# cannondale

### **SLATE, CAAD12**

Correct BB Routing and Cable Guide - KP412/

Figure A.

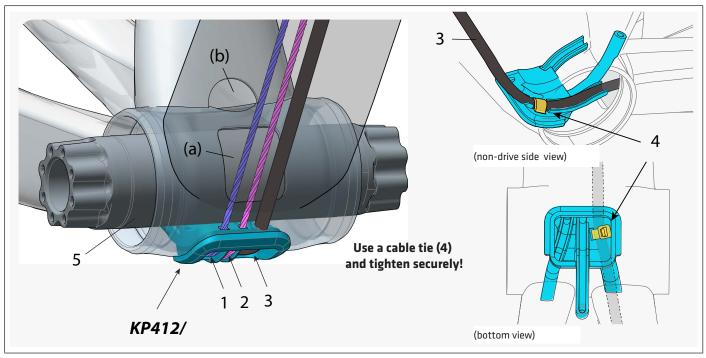
Whenever assembling or servicing 2016-2017 model CAAD12 or SLATE models inspect the internal bottom bracket shell routing:

- Make sure the internally routed rear brake line (3), rear derailleur (1), and front derailleur (2) cables exit the down tube through lower bottom bracket window (a).
   The cables (1,2,3) MUST NOT exit through the upper window (b) as this results in contact with the spindle (5).
   A SLATE bottom bracket is shown in the example; the CAAD12 BB does not have an upper window.
- Make sure the rear brake line (3) is securely fastened to the cable guide KP412/ with the cable tie (4) and the cable tie is tightened securely. No space should exist between cable guide KP412/ and the rear brake line.
- Any other internally routed cables, wires or housings must not come in contact with the spindle; this will result in abrasion damage.

**SLATE specific:** To avoid cutting the crank spindle in half, all cables and the rear brake line <u>MUST</u> exit the down tube through the lower window. The rear brake line must properly secured to the BB cable guide **KP412/** using a cable tie.

If the cables are routed incorrectly and damage has occured to the spindle, remove and replace the damaged components with new ones and correct the routing.
